**Teddington Riverside
(14/0914/FUL)**

**Flood Risk Assessment
(Addendum)**

Report K0358/2

The purpose of the work was to clarify and respond to the specific comments of the Environment Agency, made in July 2014. The Addendum is by way of clarification of the contents of the FRA but does not result in any design changes.

Figure 4-18 Proposed levels for flood storage calculation

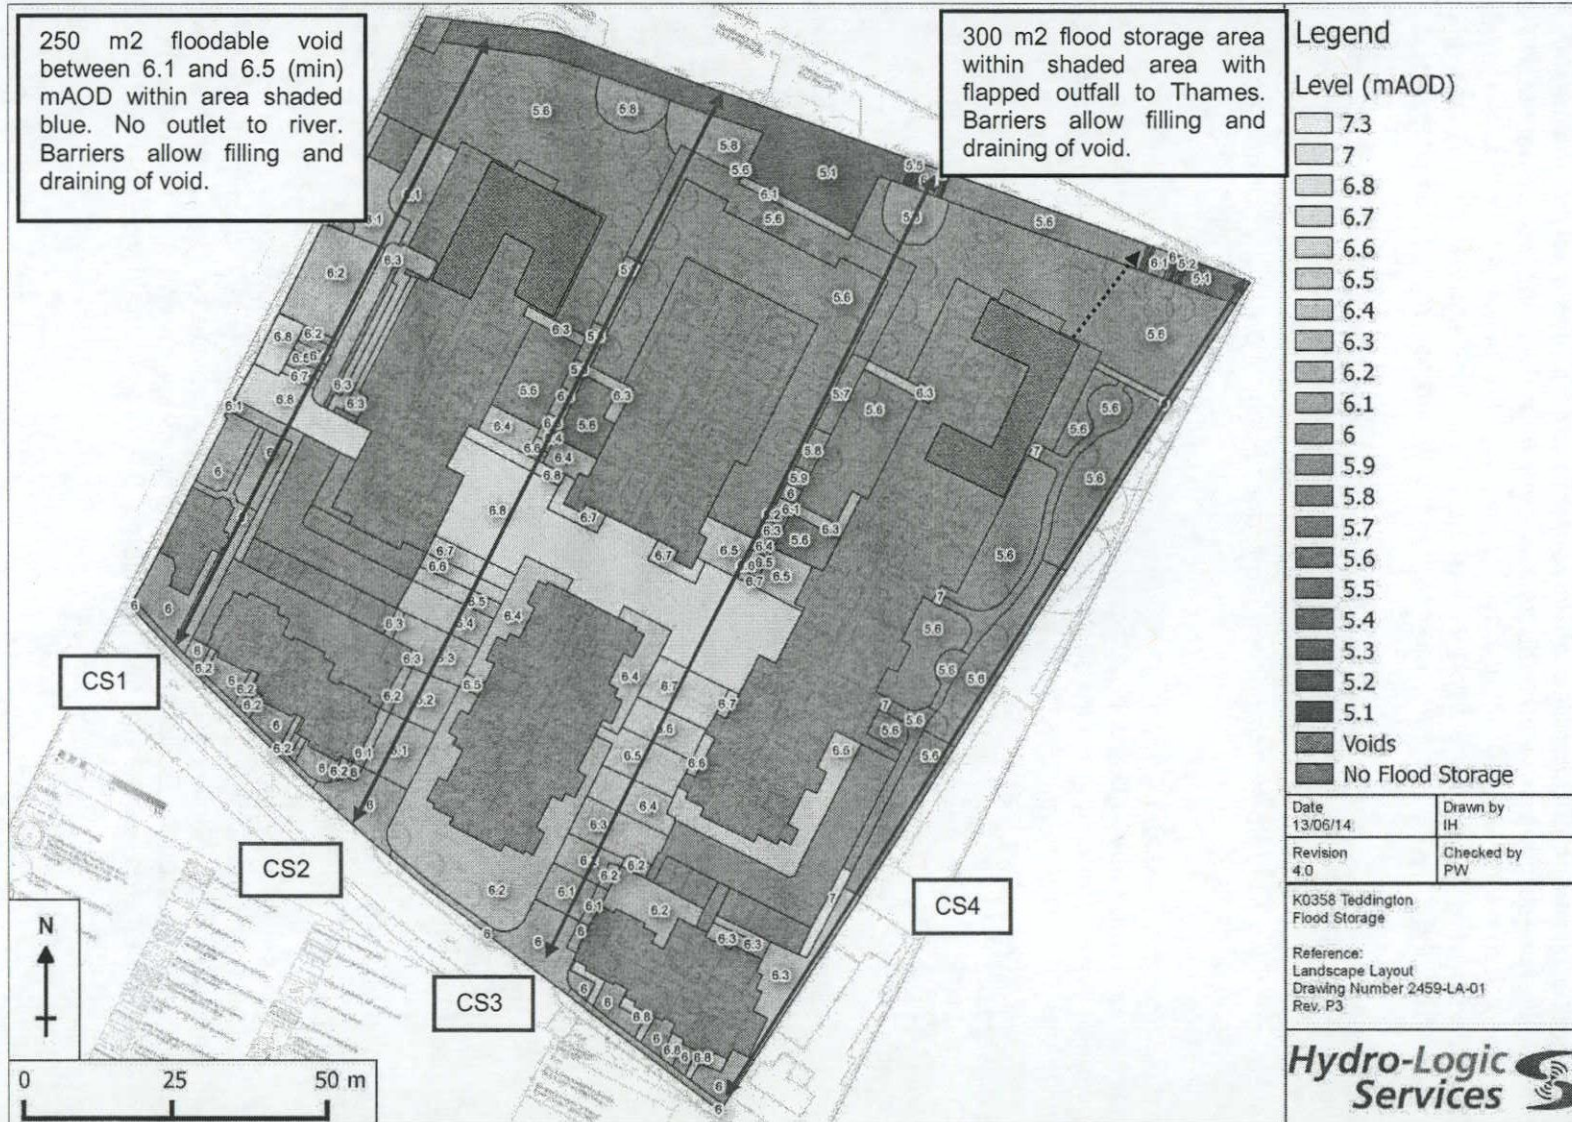
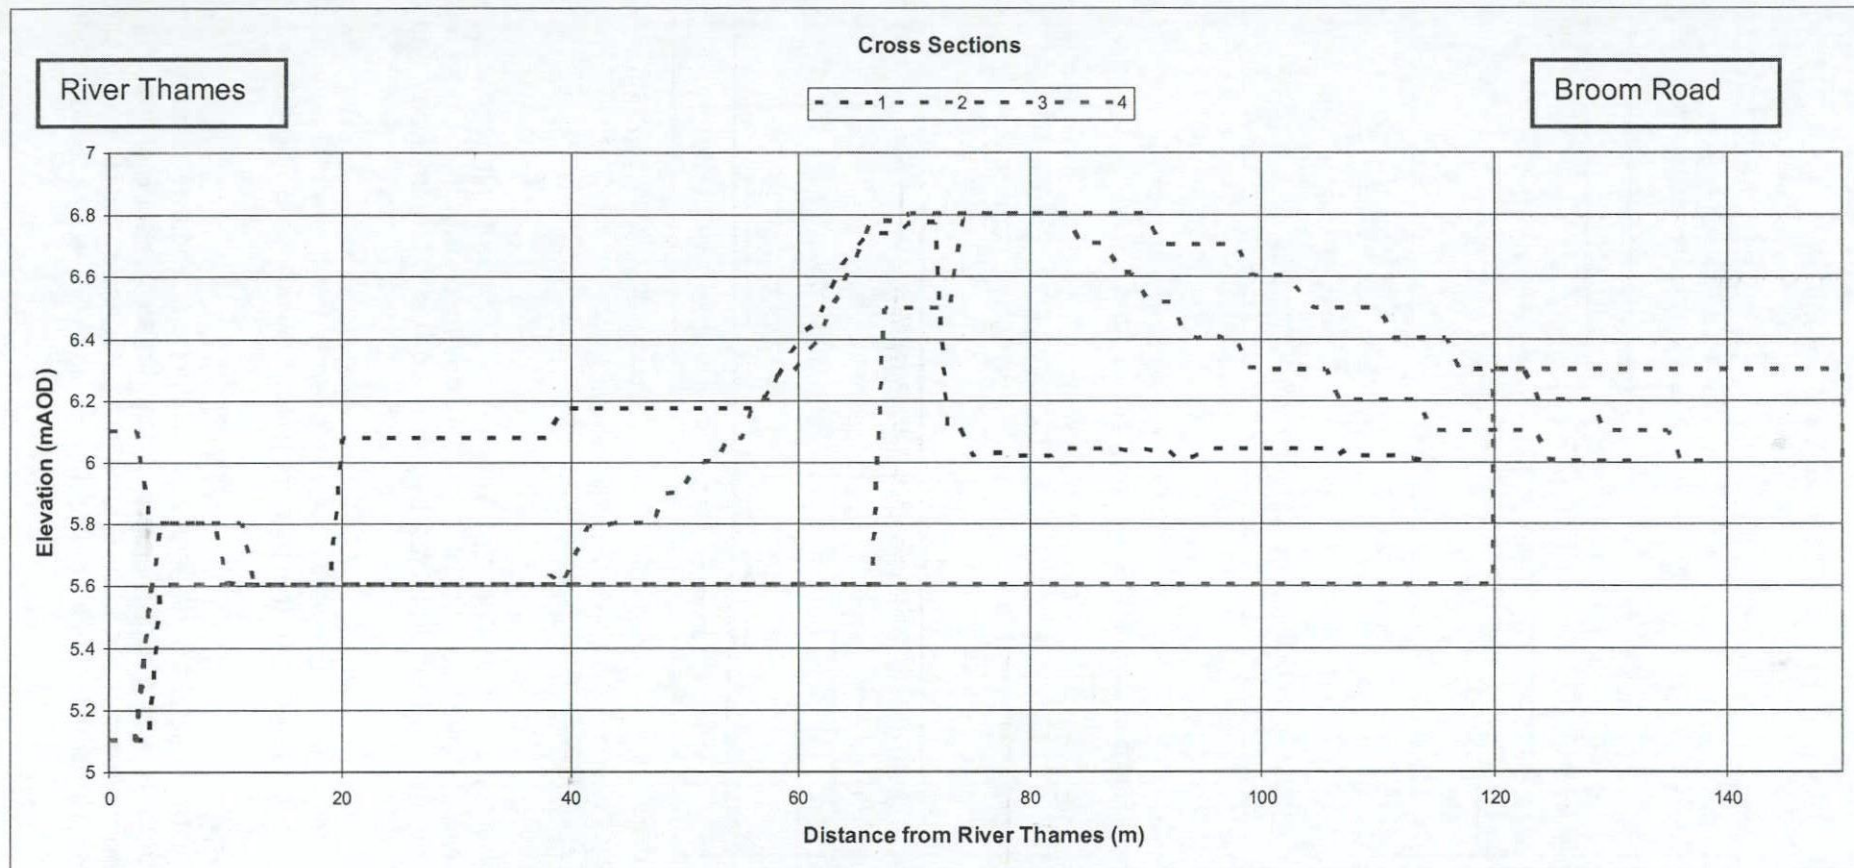
For the large compensation band up to the 6.1m AOD and the subsequent 0.1m AOD compensation bands above 6.1m, any loss of flood storage must be compensated for by the reduction in level of nearby ground, such that the same volume is available at every flood level before and after the works, and that it can freely fill and drain. It is not adequate compensation to:

- a) Excavate holes in the floodplain*
- b) Create landlocked areas of lower ground, even if connected to the main floodplain by channels or culverts*
- c) Provide low level volumes to replace high level floodplain and vice-versa.*

Further demonstration is requires to show that at every flood level after the works floodwater can freely fill and drain, as set out above.

As indicated on Figure 4-18 (page 47 of the FRA), which has been reproduced below, compensatory flood plain storage is provided in two floodable voids between Buildings A and C. These are in addition to extensive landscaping within which the general level of the gardens between Buildings A, B and C is at a level of 5.6 mAOD. The void below Building A is required to be a "minimum" of 0.4 m in height. Such a restricted space is impractical for maintenance, so the height is likely to exceed 0.4 m. This would lead to a further increase in floodplain storage following the development.

The storage below 6.1 mAOD must drain, of necessity, via a flapped outlet, as shown in the Figure. The suggested gradient is 1 in 100. The storage above 6.1 mAOD is able to drain freely to the river, since it is above the level of the embankment.

Although Figure 4-18 shows a single void under Building A and C, the detailed Basement Plans show that these voids are further sub-divided, with each sub-void having a nominal area of about 250 to 300 m². It is proposed that there is one "opening" for each of the floodable sub-voids. Assuming a plan area of around 250 m², this would provide around 400 m³ of storage between the base of the void at 4.0 mAOD and the level of the garden at 5.6 mAOD. There is clearly additional storage above this level. The time taken for the sub-void to fill would require a detailed calculation involving the rate of overtopping and the rate of filling of the sub-void. However, a rough indication of the time taken to fill a sub-void is given in the following table. This shows the time taken for the nominal 400 m³ storage to be filled for different constant depths of water in the garden – delivering different rates of flow into the sub-void. This shows that the time taken to fill the void (assuming a constant rate of flow) would range from 114 minutes (for 0.1 m depth) to 10 minutes (for 0.5 m depth).

Arrangement of Town Houses (E1 to E6) with finished floor level at 7.3 m AOD, rather than 6.2 m AOD

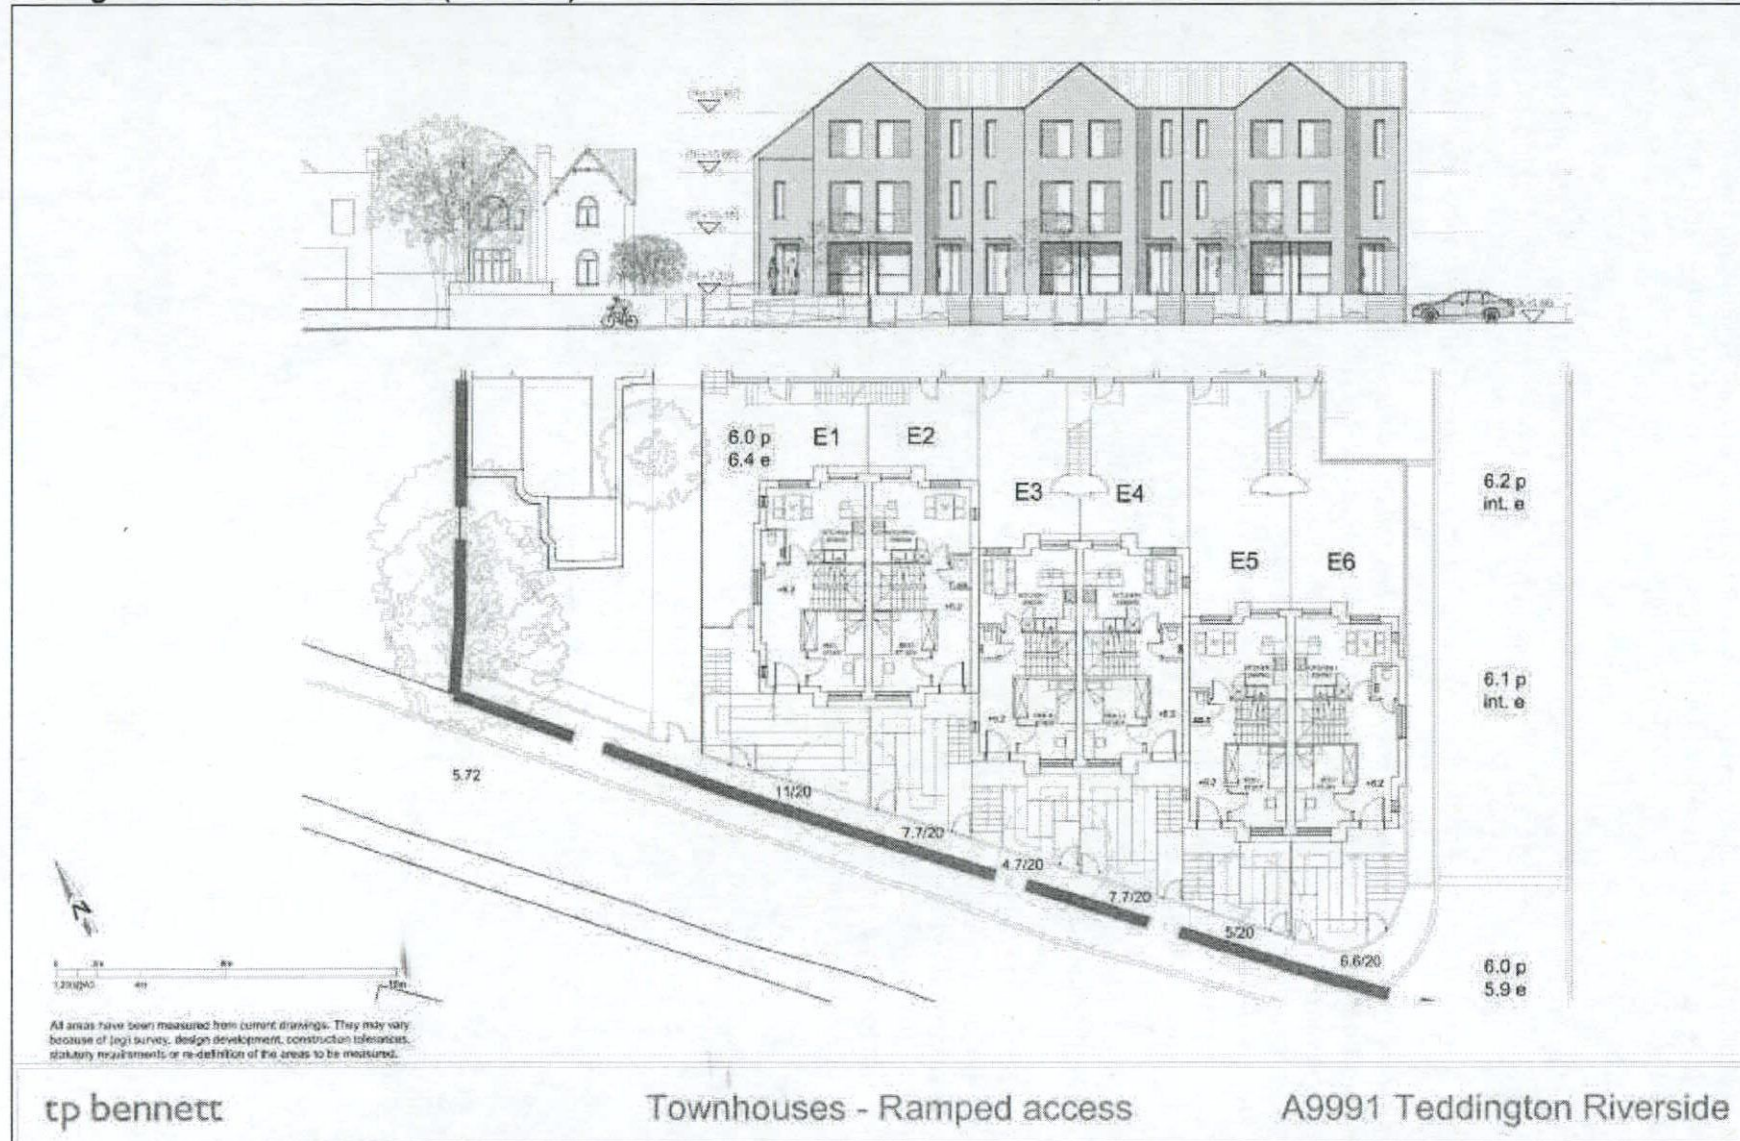
The proposed town houses along broom road are to be set at only 6.2m AOD, below the design flood event level. It is proposed that these dwelling include flood resistant measure however if any of these measures fail internal flooding of around 80cm would be experienced up to the design event. Finished floor levels should be set at design event; we would recommend that a further 300mm freeboard is allowed for.

"Illustrative material is provided below to show why the design proposal for town houses E1 to E6 is best served by the proposed internal ground floor level of these townhouses to be at 6.2 mAOD, rather than the 7.3 mAOD adopted for apartment buildings. There is a balance to be struck in all design and especially in this part of the design, where several competing considerations come into play. Flood considerations would be satisfactorily addressed using a level of 7.3 mAOD but this is neither practical nor balanced, nor is it the only way to provide a defence that is entirely robust. "

"In this particular location, streetscape continuity and setting, both of the local building of historic merit (Weir Cottage) and the Teddington Lock Conservation Area are also very important considerations, as too are Lifetime Homes criteria and Social Inclusion policies. Along with the aspiration to increase the width of the existing pavement by giving application site land over for adoption, these factors combine to make a particular challenge. The narrow existing street pavement frontage is at circa 6.0 mAOD and setting the houses at 7.3 would require incongruous lengths of unsightly quite bizarre ramped approaches along with 8 steps. "

"At the steepest gradients permitted under Part M 1:12, we can only rise in 2 m long ramp increments before we need to have a landing and this will only rise up 166 mm in each increment (B.Reggs M Table 1) so 1300mm divided by 166mm equates to 8 such short ramps and 7 landings, before we arrive at the front door landing alongside the individual steps up to each townhouse. There is simply not the space available to achieve this even if it were visually acceptable, which it could never be. It would also lead to a loss of flood plain storage. Taking a more gentle ramp at say 1:15 this would require 20m of ramp in 4no. 5m lengths with 3 number landings before reaching the final front door landing shared with the steps; again an incongruous proposition. Once again, there is simply not the space to provide this. On the drawing below which is based on the 1:15 option we would only ever be able to provide approximately 50% of the required ramping at most and we would lose the three proposed trees intended to green the landscape and street continuity context where intermittent trees are a feature of the road."

"In terms of the issue of streetscape and setting, the bizarre extent of ramping would not only be visually inappropriate and detrimental to setting and streetscape, but in addition a 7.3 mAOD ffl would entail a circa 15% increase in bulk of the elevation as a result of the increase from 6.2 AOD to 7.3AOD. This would be at the expense of streetscape and setting criteria. "

"Set against all this, it is possible to provide waterproof walls, specify a flood proof door to BS/EU widely accepted standards and the entrances themselves could be further protected by the detail design incorporating flip up automatic barriers or demountable barriers."

Furthermore, drawings have been provided by the architect on page 13 in support of this.

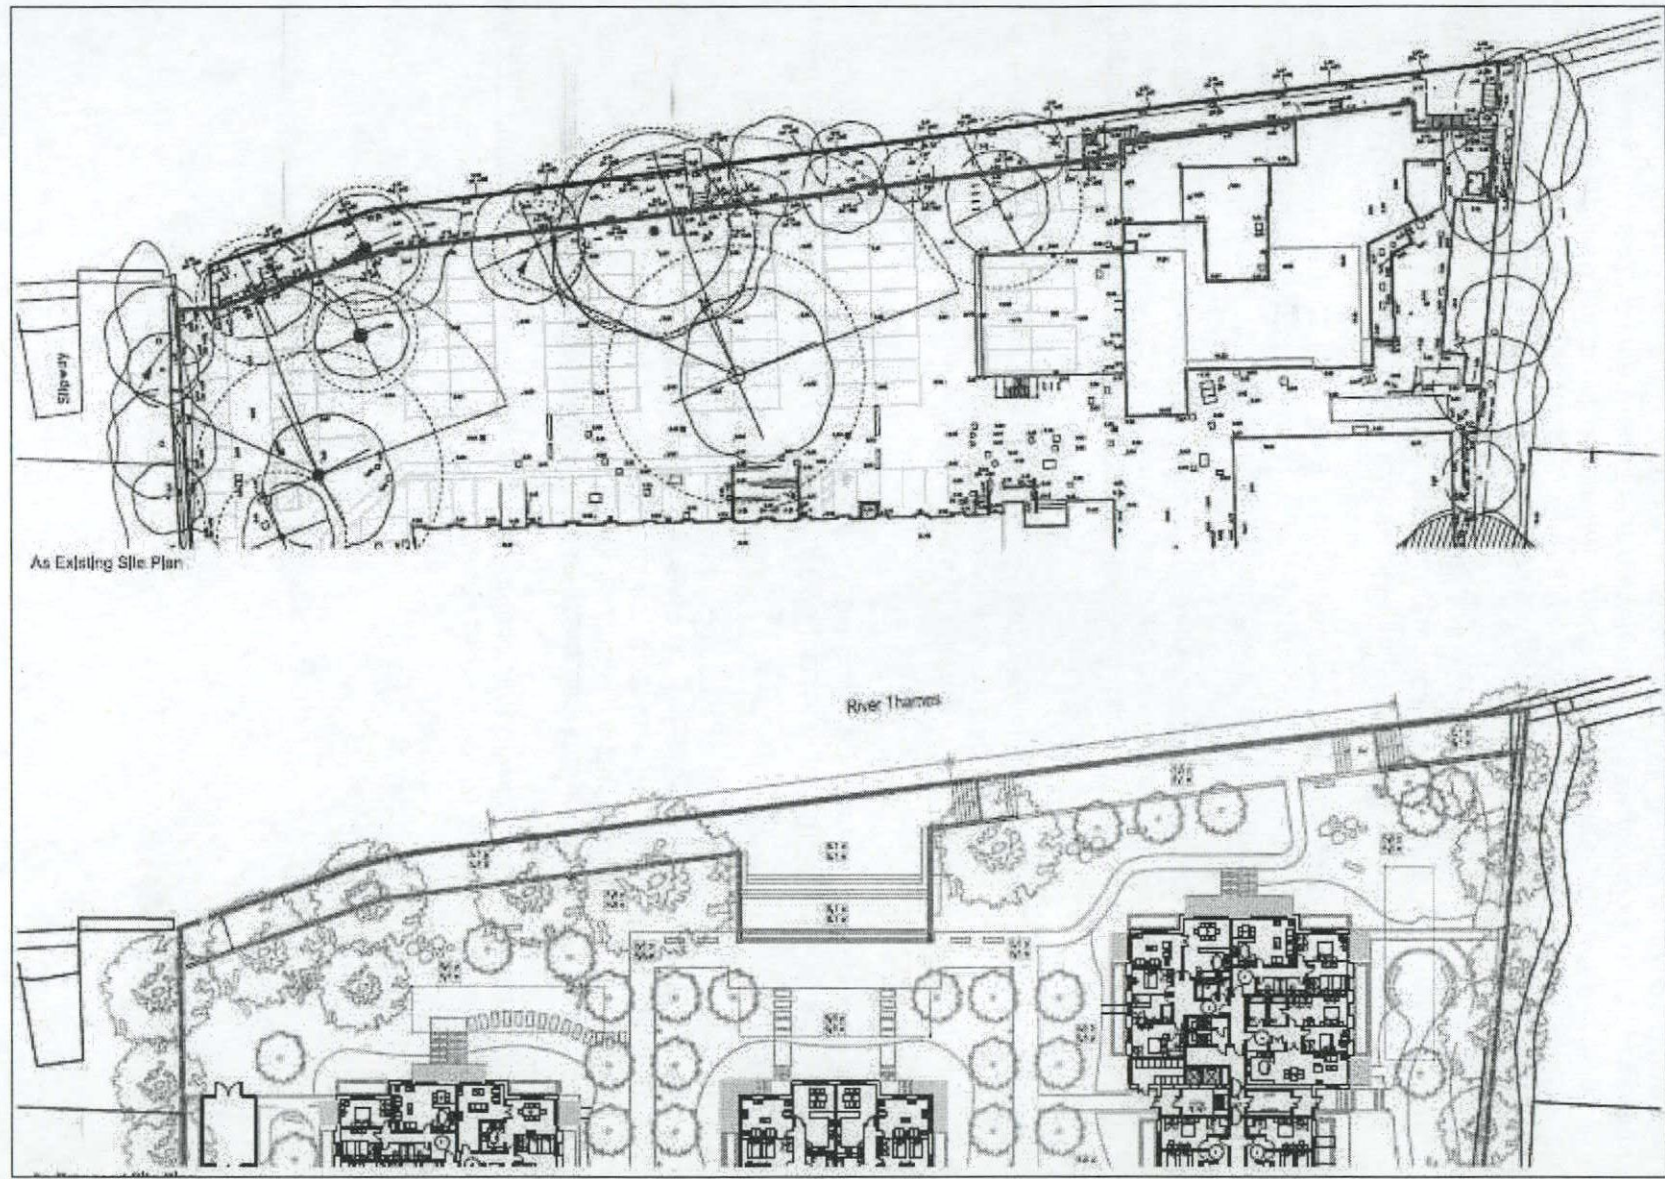
Section 4.2.4 considers the realignment of the existing tidal defences along the river frontage. The text and figure 4.4 appear to indicate that it is proposed that the east end of the wall would be set forward of its current position – closer to the river, although we note in the revised FRA the length of wall moved forward has been reduced. This could result in a loss of flood storage and may also limit the Richmond on Thames' aspiration to provide public access across the river frontage. Further information should be provided to demonstrate the total realignment proposed will not result in a loss of flood storage.

Discussion point: *We would like to understand the revised alignment of the flood defence and the impact this has on the need for further compensation.*

The proposed alignment is shown in Figure 4-5 of the FRA (page 34). A further drawing has been provided below showing the existing and proposed alignments. This shows that for approximately half of its length, the alignment has not changed.

It is shown in Table 4-4 on Page 42 and Table 4-6 on Page 45 that there is no loss of floodplain storage. This is supported by the comparison of the relative areas of the riverside paths (before and after realignment) in Figure 4-5.

The provision of public access requires balancing with other constraints, including flooding. The proposed alignment does make provision for wheelchair access to the water's edge adjacent to Building C and which is considered to be a valuable attribute.

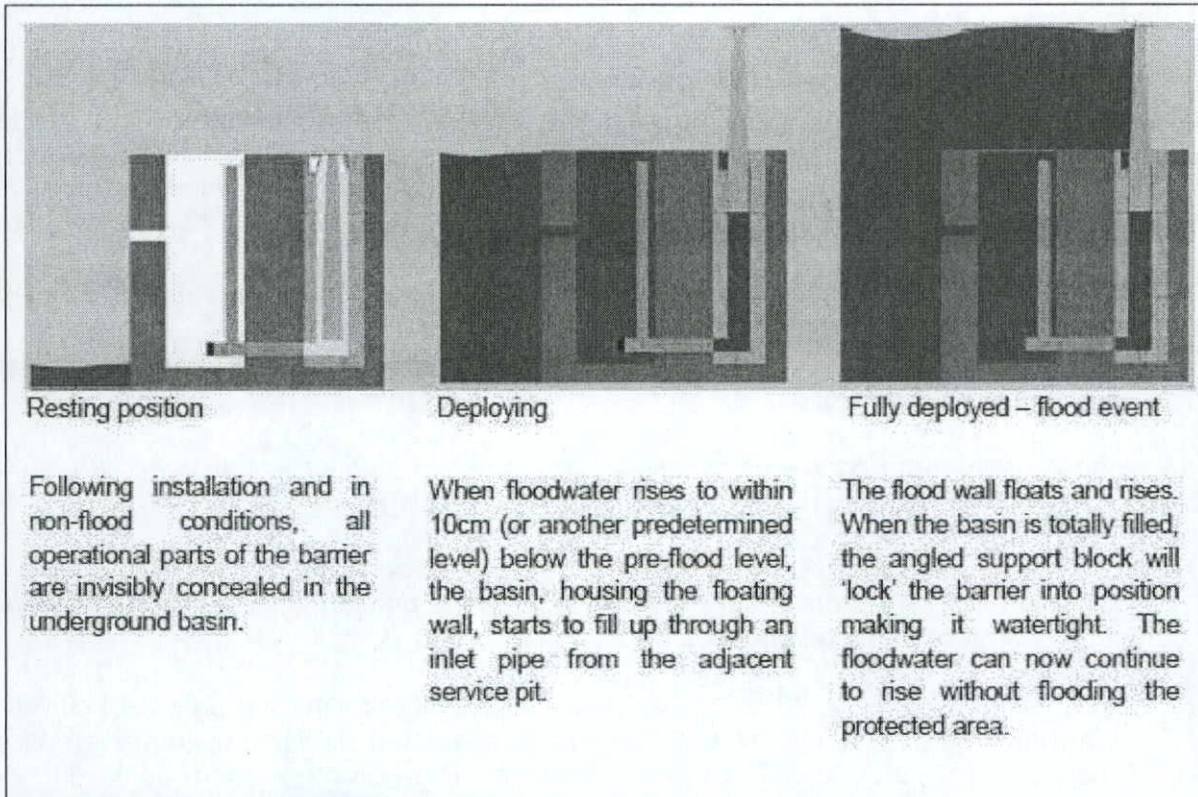
The sketch in figure 4.8 indicates how the walls could be raised by 80cm to 6.9m AOD in line with TE2100 requirement near block B. However the proposal includes the use of flood gates, we would not be supportive of the use of these gates that would be reliant on human action.

In addition, consideration should be given on impact of raised wall at the two locations it crosses the riverside path– this may impact on wheelchair and pushchair access along the proposed riverside path.

There are three sets of steps where gates are proposed in the raised defences. All feature voids beneath the steps. The voids would be suitable for installation of self activating flood barriers, as shown in the image below. Such barriers are provided by UK Flood Barriers and have been installed at Cockermouth following the recent flooding there. It is recommended that these are configured as "automatic gates".
